UNITED STATES PATENT AND TRADEMARK OFFICE

Office Action Summary

10/693,324

DOMGAARD, NEAL H.

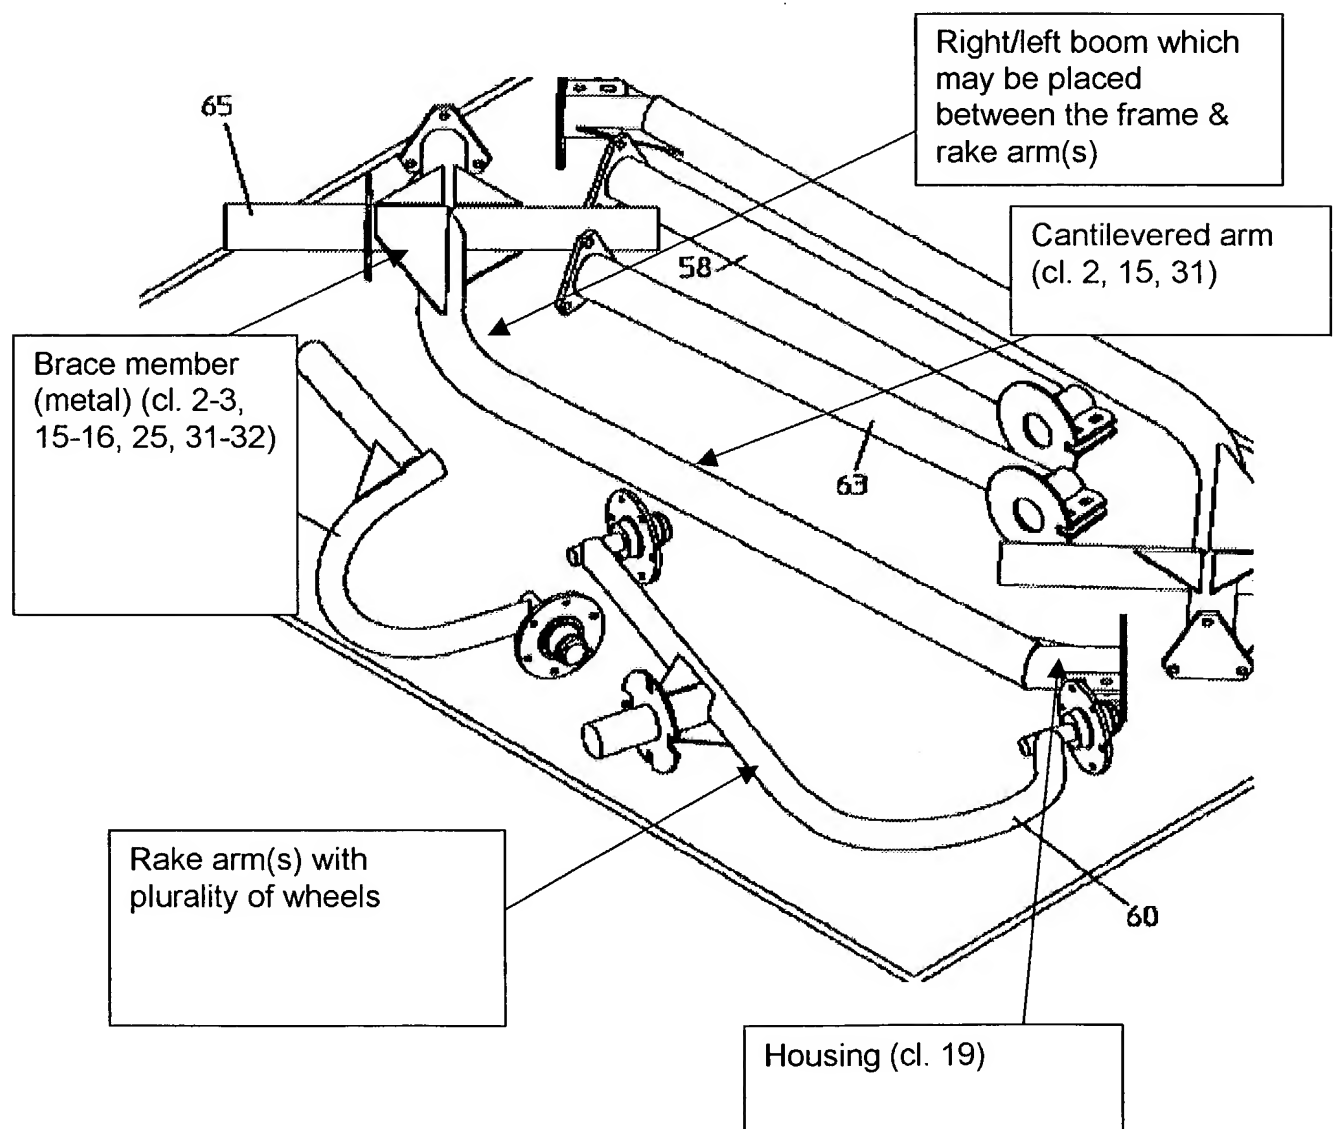
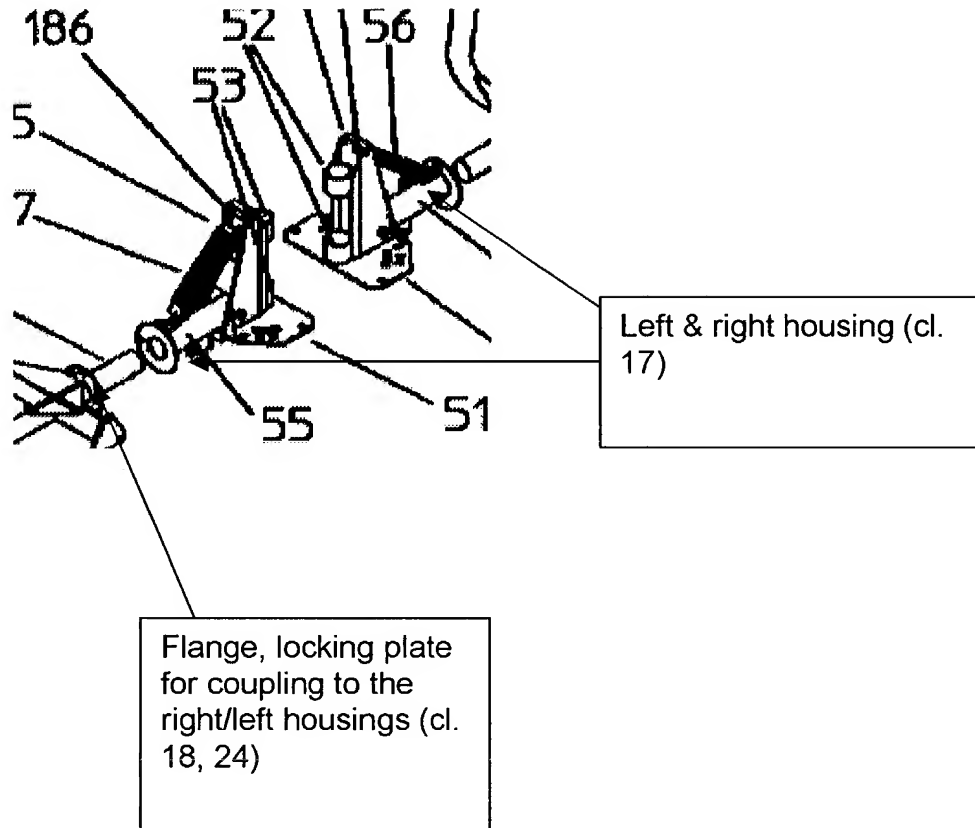
6. Claims 1-3, 14-20, 30-32, 36-42 are rejected under 35 U.S.C. 102(b) as being anticipated by Menichetti et al (6000207).

Menichetti discloses and as shown bellow:

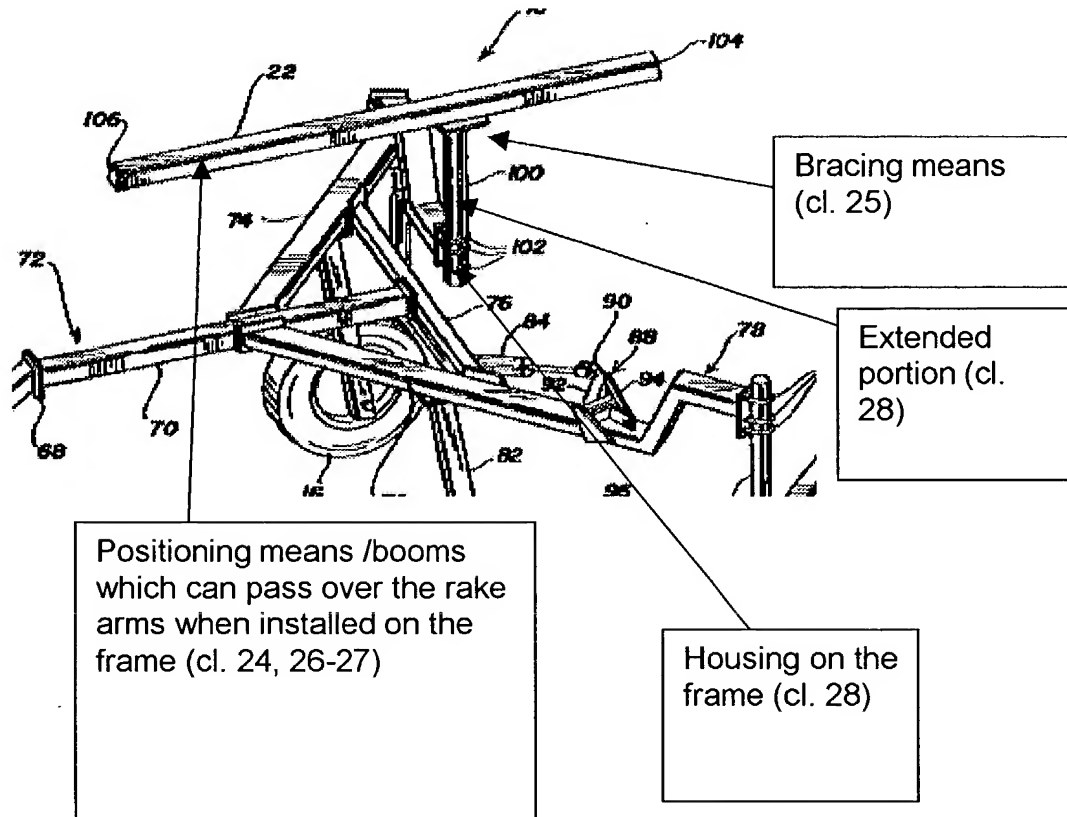
8. Claims 24-29 are rejected under 35 U.S.C. 102(b) as being anticipated by Wright et al (5956934).

Wright discloses and as shown bellow:
